**Karth Lake Improvement District Board**  
**Minutes of Regular Meeting Tuesday, February 9, 2021**  
**Approved: April 13, 2021**

### **5.3.1. Remediation of BMP #1 Site**

**GRADING AND UTILITY PLAN**

**KARTH LAKE STABILIZATION PROJECT**

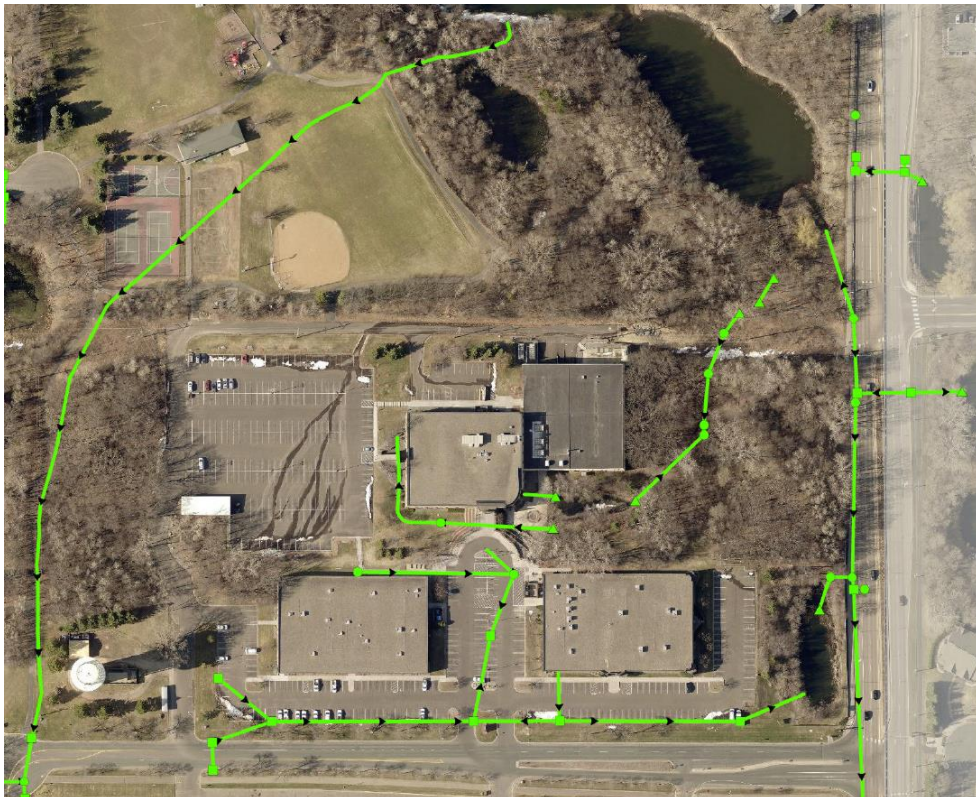
1. Q: On the figure below, do all the yellow lines indicate pipes? Please explain what each node and line represent. A: David: Yes, all the yellow lines are pipes or another water conduit such as a culvert.

2. Q: Show where BMP #1 starts and ends on this photo. A: David: The BMP #1 remediation is not on this map. See schematic below.
3. Q: Are the 2 nodes east of the northmost building a low spot where filtration takes place? A: David: Yes.

4. Q: Please explain the elements of the schematic of the Grading and Utility Plan. Q: David explained it.
5. Q: Does the remediation include any mechanism to catch solids -- like a grit chamber — so they do not get in the lake? A: David: The plan as drawn does not have a grit chamber, but a grit chamber will be included. **Action:** David will send us an updated schematic with the grit chamber shown. [That schematic was received after the meeting and is attached at the end of these minutes.]

6. Q: Is there any mechanism to capture oil products and other pollution and nutrients that are contained in the runoff from the parking lot and road before they enter the lake? A: David: No filtration is provided. This remediation step only captures grit and moves the water down the hill without causing more erosion. **Action:** David plans to apply for another grant in the future that will divert the water into a holding pond so it is filtered before it empties into the lake.

**5.3.4. Lake Level Gauge Questions for David**

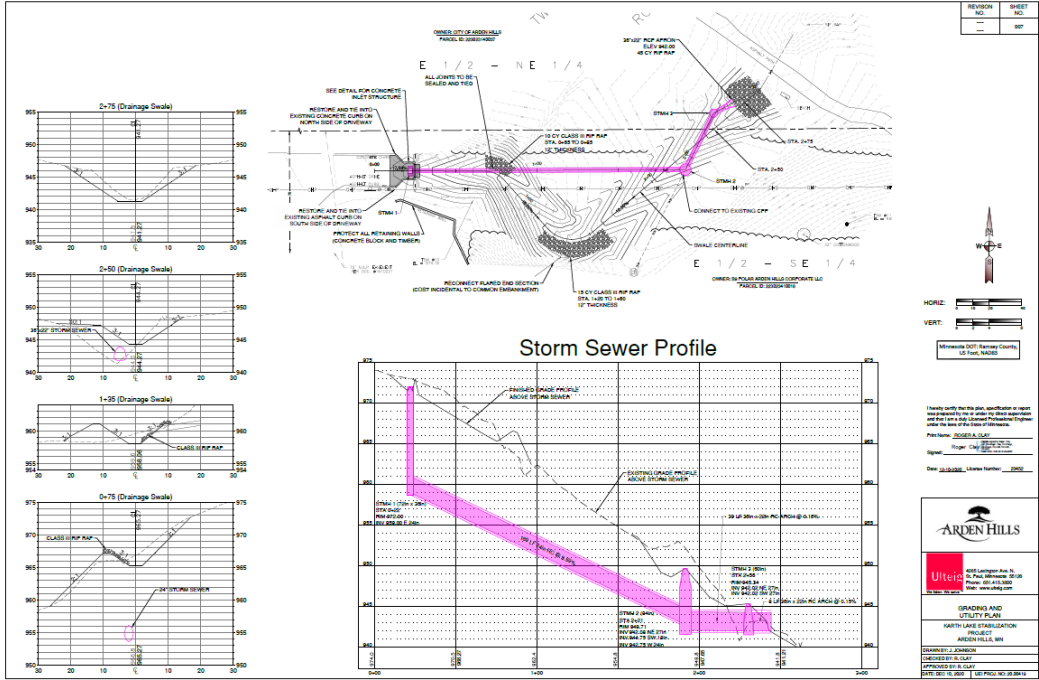
- 1. Does the gauge measure actual depth or is it just a reference point?**
- 2. How is it anchored? Action:** David will research the above.
3. Renee suggested it would be helpful to measure the lake levels in conjunction with biweekly CAMP samplings. The board agreed.
